Serial No. **09/898,040**

Docket No. **K-0280**

Amendment dated **April 12, 2006**

Reply to Office Action of **October 12, 2005**

**Amendments to the Drawings:**

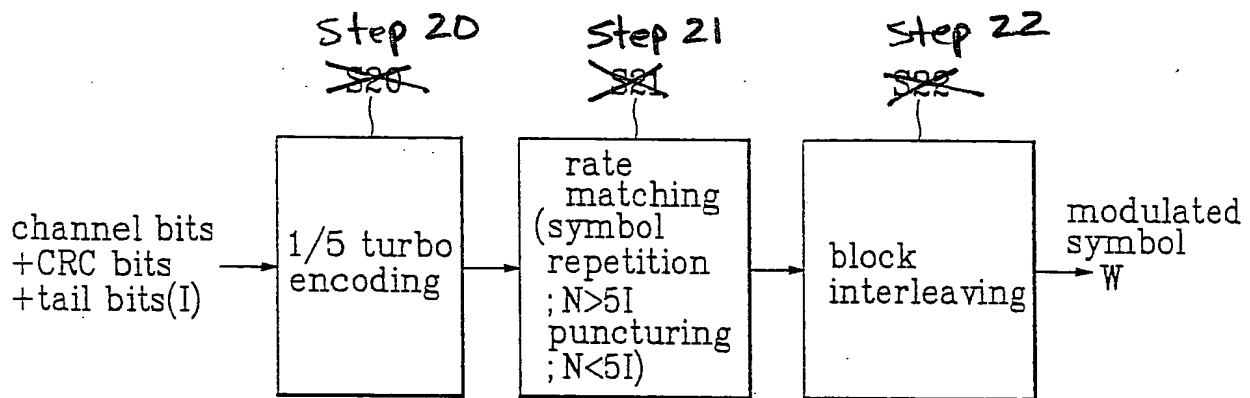
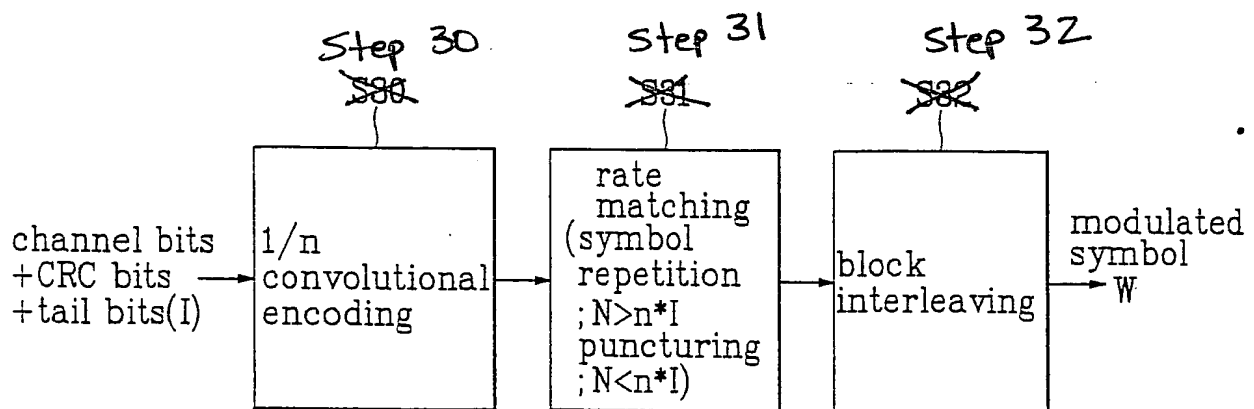
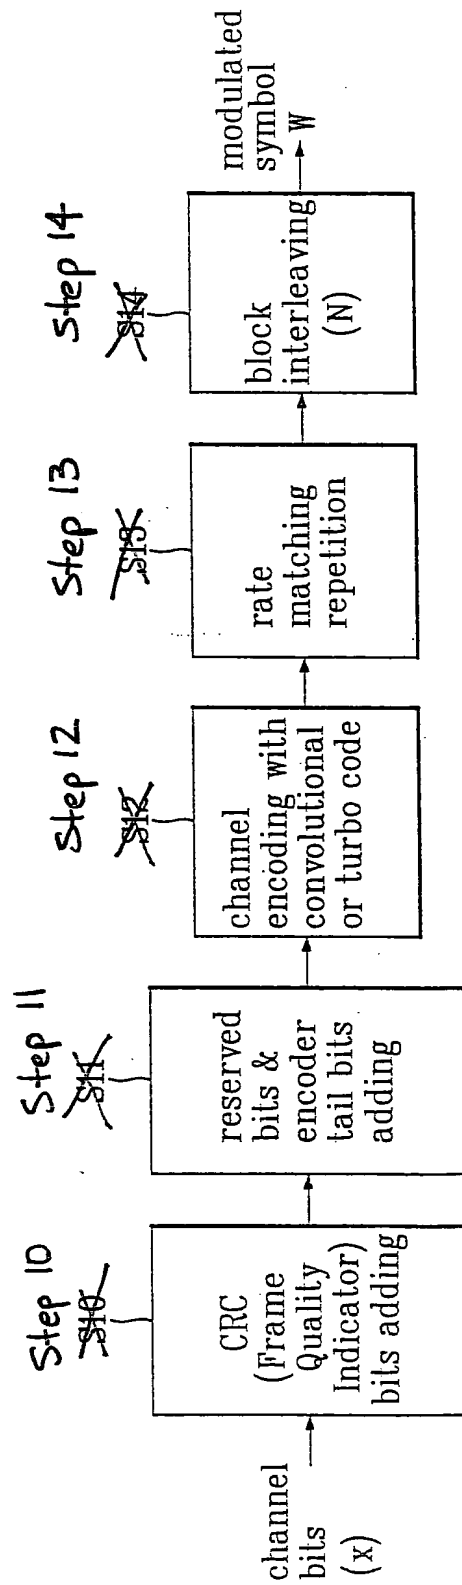
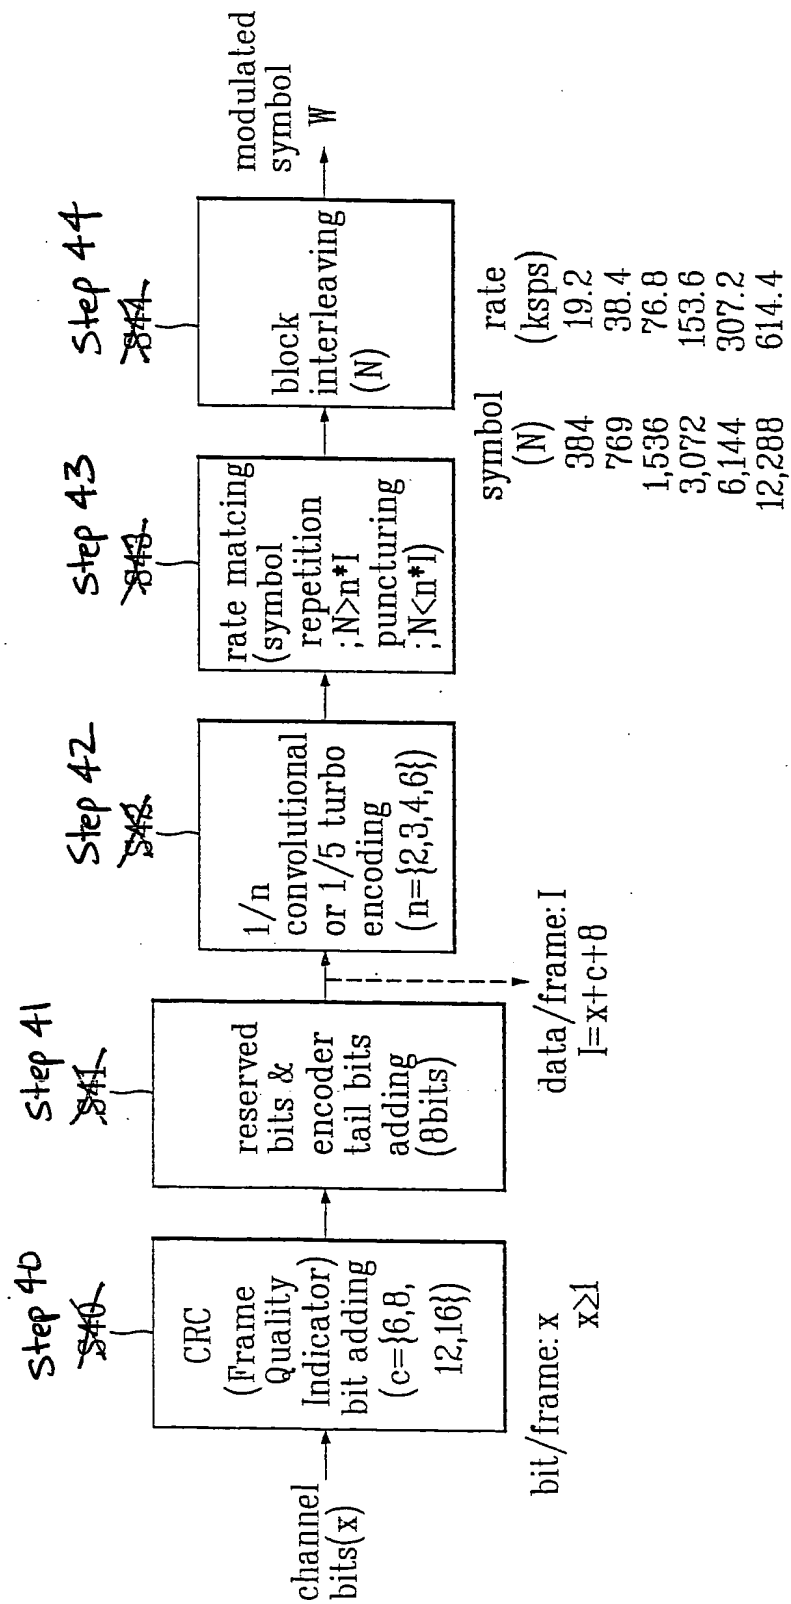
The attached drawings include changes to Figures 1-5. These sheets, which include Figures 1-5, replace the original sheets including Figures 1-5.

The drawings stand objected to based on minor informalities. Although the acronym “S” is standard labeling for steps, the drawings have been amended per Examiner’s request. Hence, withdrawal of this objection is respectfully requested.
